Procedure for disabling protection circuit that cuts input exceeding 5.15 V from AC adapter

[*1] RTP0RC77951SKBX010SA00 [S/N 3001-3300]

Starter Kit Bottom side

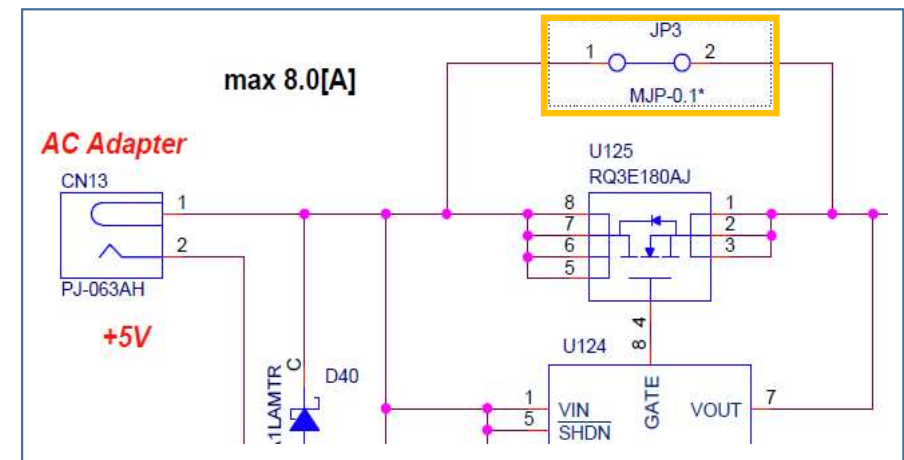
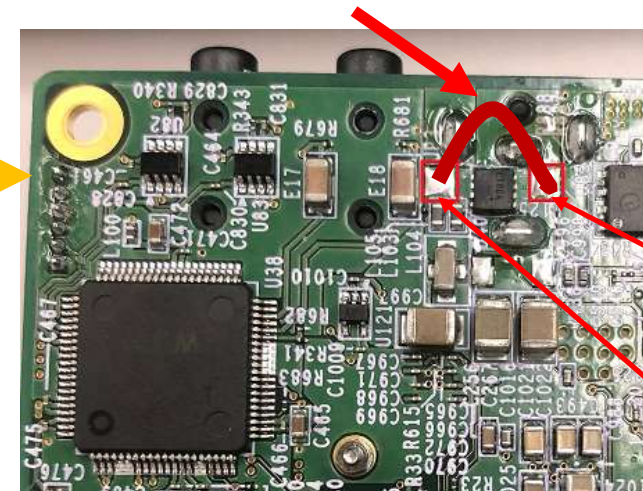
Procedure for disabling protection circuit that cuts input exceeding 5.4 V from AC adapter

You can disable the protection circuit by short-circuiting JP3.
